LIGHTS FLICKERING REPAIR

Bulletin Type:	SRP	Publication Date:	December 2024
Bulletin #(s):	24-020	Make(s):	Highland, Starcraft
Job Code(s):	<i>If affected unit has warranty remaining, submit your claim following the normal process</i>	Model(s):	Range Lite TT, Mesa Ridge S-Lite TT, Silverstar S-Lite, Range Lite Air TT, Olympia Lite TT, Super Lite Maxx TT, Super Lite TT
Flat Rate(s):			Model Year(s):

Incident:	Lights Are Flickering When The Water Pump Comes On During Camping
Affected Units:	2022-2025 Highland Range Lite TT, Mesa Ridge S-Lite TT, Silverstar S-Lite, Range Lite Air TT, Olympia Lite TT; certain 2022-2025 Starcraft Super Lite Maxx TT, Super Lite TT
Parts List:	1 - HOLDER,FUSE 5AMP IN-LINE (Jayco Part #0170414) 1 – CONNECTOR,SPLICE 3 WIRE CLR PLSTC WAGO 12-24GA MFR# 221-413 (Jayco Part # 0288118) 1 – CONNECTOR,SPLICE 5 WIRE CLR PLSTC WAGO 10-20GA MFR# 221-615 (Jayco Part #0348607) 1 – FUSE,15AMP ATC/ATO-15 SPADE (Jayco Part #0038536)
Misc. Tools & Supplies:	Wire Strippers Screw gun with square head bit

Fig. 2

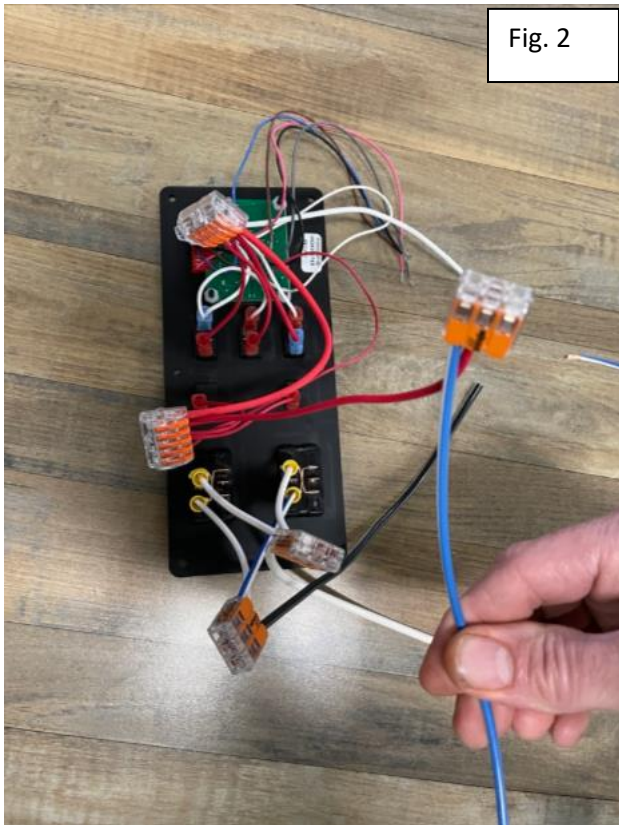
- Figure 1 shows the incorrect configuration that it is now.

2. Disconnect the power wire coming in that powers the monitor panel (water pump & water heater) and middle 2 switches (interior & exterior light switches). (Figures 2-3)

Fig. 4

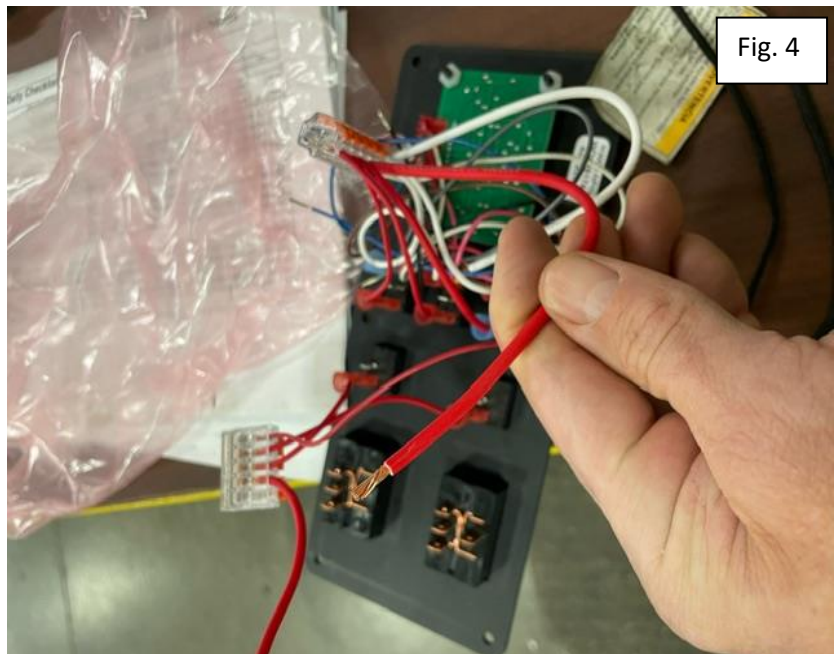
3. Disconnect the Red wire that feeds the monitor panel which should be (water pump, water heater switches) this wire should be going to a 5 hole wago. (Figures 3 and 4)
